CERTIFICATE OF APPROPRIATENESS

Property: 615 Bayland Avenue, Lot 13 and W 5 ft of Lot 14, Block 29, Woodland Heights Subdivision. The property includes a historic 2,057 square foot 2-story wood frame single-family residence with a detached garage situated on a 5,500 square foot interior lot.

Proposal: Alteration-Siding: Work without a COA.

West Side of house

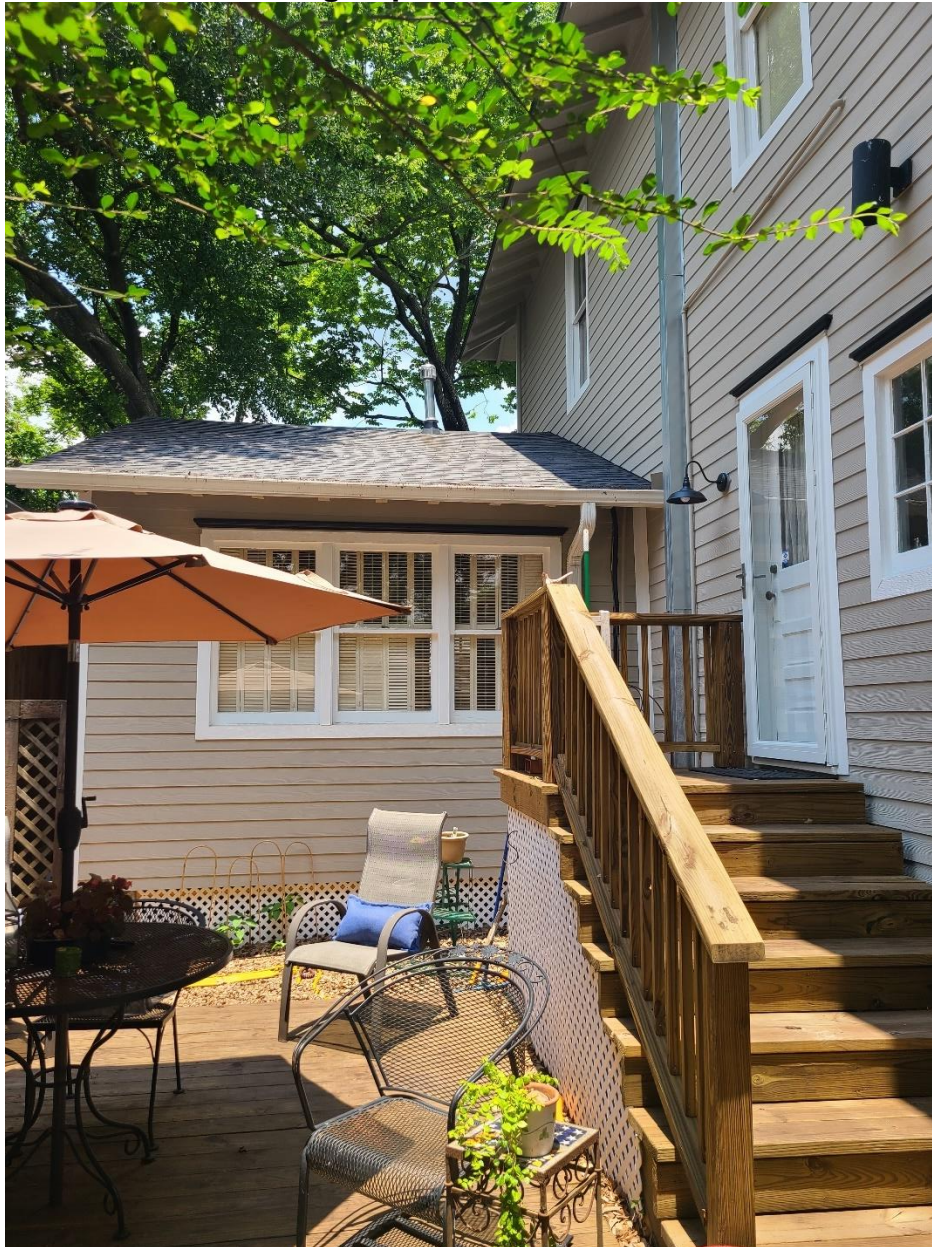
<i>The textured cementitious siding that replaced the original smooth wood 117 wood siding is not appropriate.</i> |

<i>The textured cementitious siding that replaced the original smooth wood 117 wood siding is not appropriate.</i> |

<i>The textured cementitious siding that replaced the original smooth wood 117 wood siding is not appropriate.</i> |

Recommendation: Denial - does not satisfy criteria; Staff recommends issuance of a COR for the work as completed and doubling of the application fee for the permit as allowed
